## NOTICE OF NON-PERFORMANCE

# INSPECTION REPORT

Electrical Corporation:	Pacific Gas and Electric Company
Report Number:	PAD_PGE_RMA_20251216_1256
Inspector:	Romeo Marroquin Ajcac
WMP Year Inspected:	2025
Quarterly Data Report (QDR) Referenced:	Quarter 2 (Q2)
Inspection Selection:	Energy Safety viewed the contents of the Q2 QDR and performed an analysis that resulted in the selection of the WMP initiatives and locations referenced in this report.
Relevant WMP Initiative(s):	8.1.2.10.5 - Non-Exempt Expulsion Fuses
Date of Inspection:	December 16, 2025
City and/or County of Inspection:	Angwin, Napa County
Inspection Purpose:	Assess the accuracy of Pacific Gas and Electric Company’s QDR data, completeness of its work, and performance of requirements.

Structure ID: 110460390

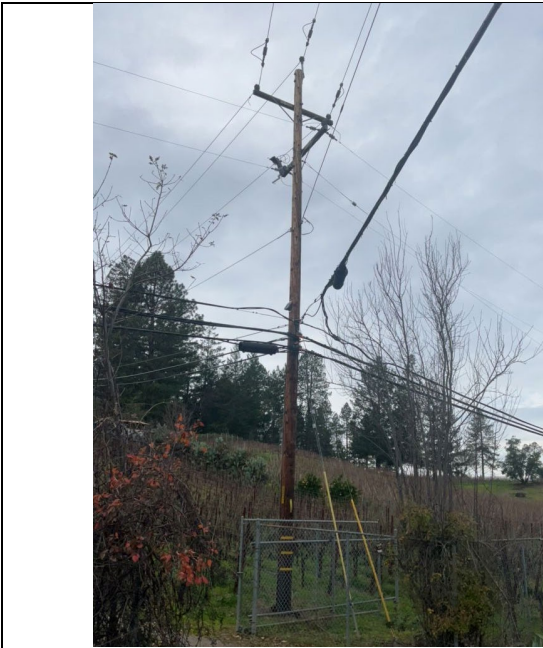
Deficiency 1. Energy Safety observed that in implementing 2025 WMP initiative 8.1.2.10.5 - Non-Exempt Expulsion Fuses, PG&E failed to complete the installation of non-exempt expulsion fuses on Pole ID 110460390, Grid Hardening ID 31699669 at coordinates 38.5714506595772, -122.447841100213. Energy Safety considers this non-performance to be in the Minor risk category. PG&E must complete a corrective action for this deficiency by 12 months of this notice.

In the 2025 Q2 Quarterly Data Report submission, PG&E reported that work on WMP initiative 8.1.2.10.5 – Non-Exempt Expulsion Fuses was completed at Pole ID 110460390, Grid Hardening ID 31699669 at 29-165 Diogenes Dr, Angwin, CA, 94508, USA, 38.5714506595772, -122.447841100213. At this location the inspector observed that an exempt fuse was left in the open position in its cutout and was also disconnected from its primary line. The inspector's observation is documented in Deficiency 1 photographs, which are attachments to this report. Photo numbers IA1Img1, and IA1Img2, depict the exempt fuse in the open position and disconnected from its primary line.

1. The inspector observed an exempt fuse in the open position in its cutout.
2. The inspector observed that the exempt fuse's cutout was disconnected from the primary line.
3. The disconnection of the cutout from the primary line indicates that the work was not completed, even if leaving the fuse in an open position would be considered normal practice.

**IA1mg1:** Exempt fuse is disconnected and unplugged.

**IA1mg2:** Exempt fuse is disconnected and unplugged (close view).
